Core Bus Corridor 7: Liffey Valley - Preliminary Submission

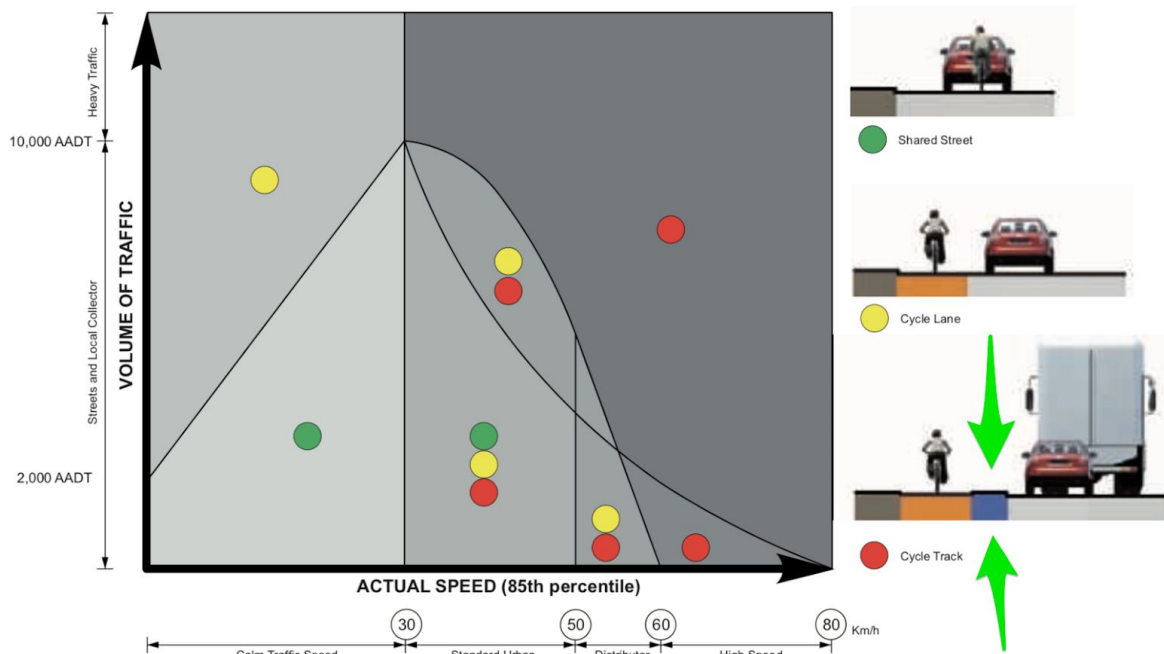
We recognise that achieving a 2.5m wide cycle track on all portions of this route may be challenging, however it is possible to achieve this width along large segments of the route by widening into the median or using grass verges beside the proposed cycle track. In constrained areas a cycle track width of 2m is acceptable, but should be implemented with caution.

5 Lamps Junction along North Strand - Junction Design Template

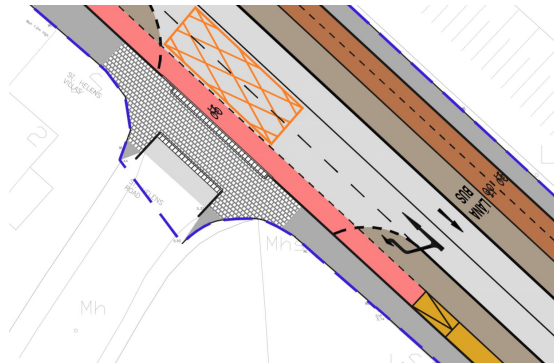
The junction design also segregates pedestrians and cyclists by providing parallel crossings and designated spaces. This would eliminate shared spaces for pedestrians and cyclists. Shared spaces are disliked by pedestrians, cyclists and by people with disabilities. Parallel crossings also mean that cyclists don't have to use islands in the middle of the road that frequently are too small for bikes to easily manoeuvre around.

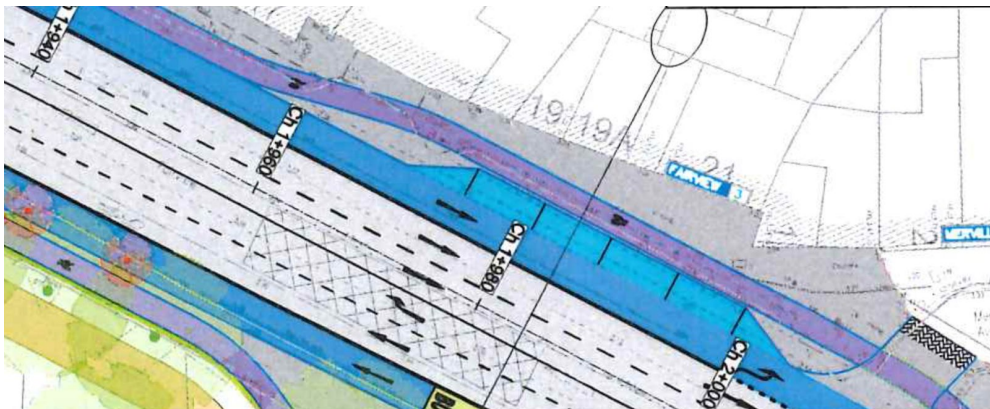
Only 4 of the 53 bus stops on this route have bus stop bypasses, despite there being ample space for them along the route.

3.9 Perpendicular Parking on Ballyfermot Road

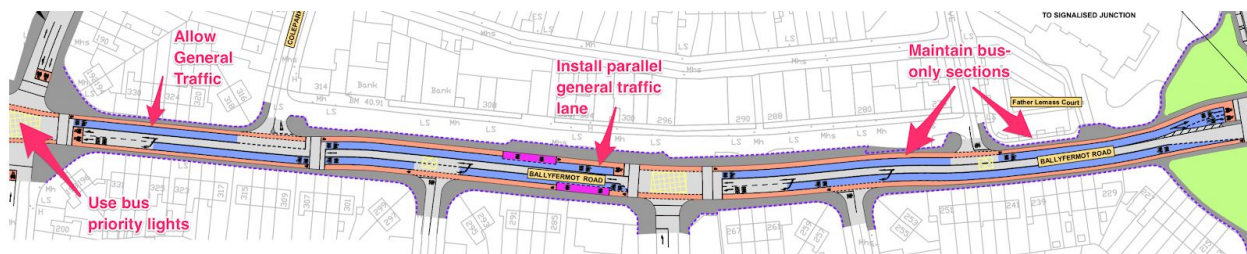
The perpendicular car parking on map 11 should be reconsidered. Perpendicular parking, particularly on a busy main road like this is not appropriate. Vehicles will be forced to reverse out into traffic with poor visibility over the cycle lane. Some of the parking is quite close to the junction too. The car parking should be converted to parallel with a parking protected cycle track. Nearby alternate locations could be used to supplement car parking in the area.

3.18 Primary Route 7A - Mount Brown, James' Street, Thomas Street

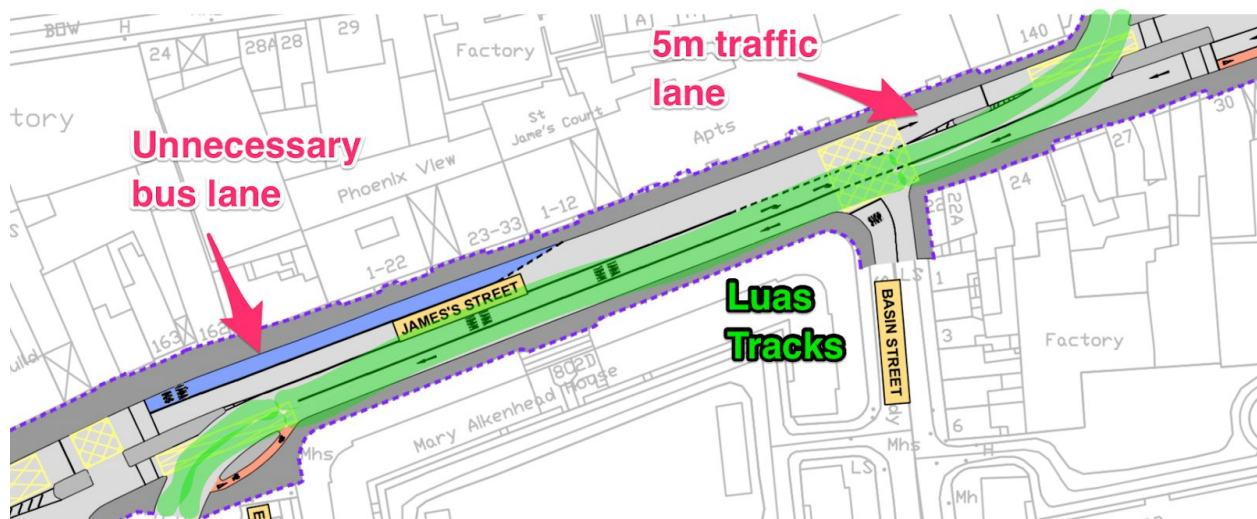
On Mount Brown, James's Street and Thomas Street cycle tracks must be provided. The road is 50km/h with a high AADT, and will continue to do so even after the introduction of the bus gate at Mount Brown. This is primary route 7 of the GDA Cycle Network Plan and a key link for the inner city. It links key destinations like Royal Hospital Kilmainham, St James' Hospital, St Patrick's Hospital, Guinness Storehouse, the Digital Hub to the city centre.
